MEMORANDUM

Subject: Addendum No. 3 – CML 25-005 Carnegie Gutter Sealing Project
Summary of Virtual Meeting
Questions and Answers

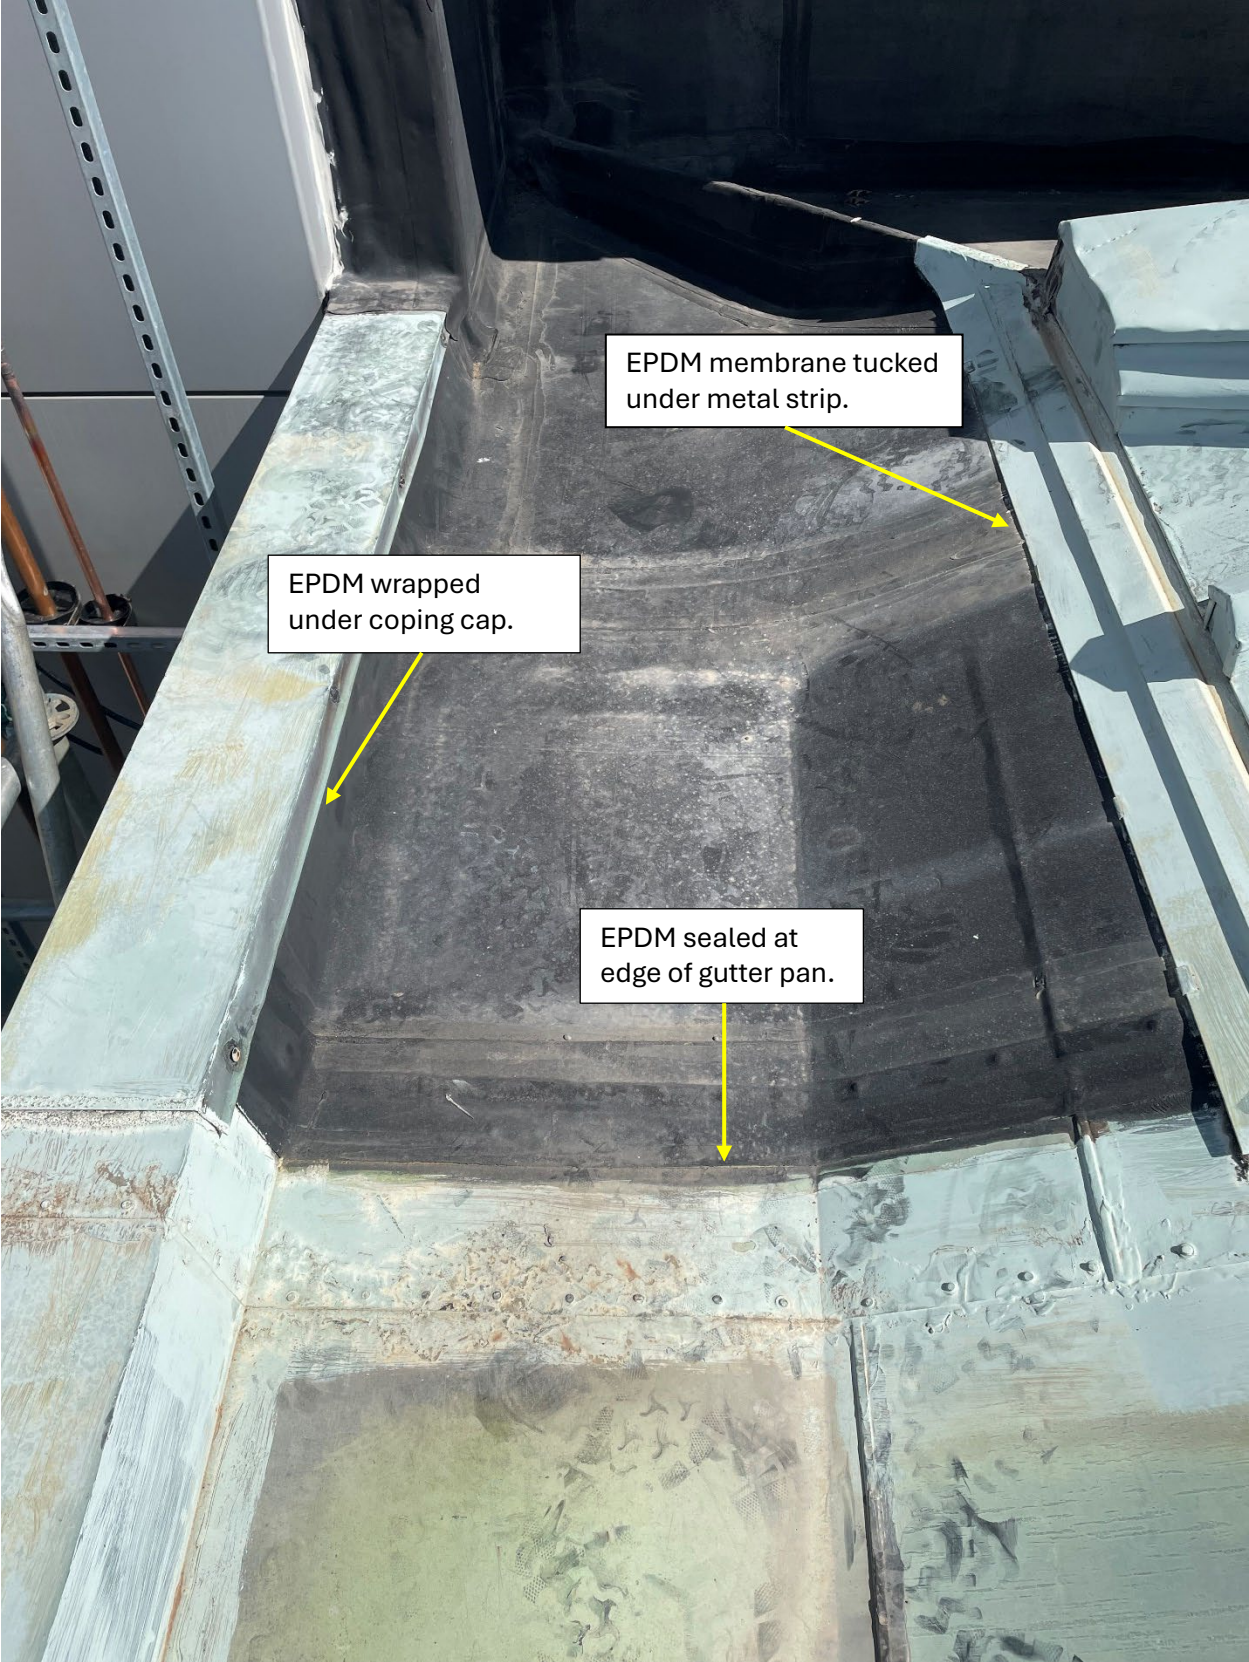
Q1. Does the EPDM get installed underneath the flashing of the existing copper roof or is it getting stripped in on top?

Q2. What is getting reinstalled on the wall section where the EPDM goes up the wall where the two buildings meet?

A1. See attached pictures which show how the EPDM and metal sections are configured.

A2. See attached picture

EPDM membrane tucked under metal strip.

EPDM membrane tucked under metal strip.

EPDM wrapped under coping cap.
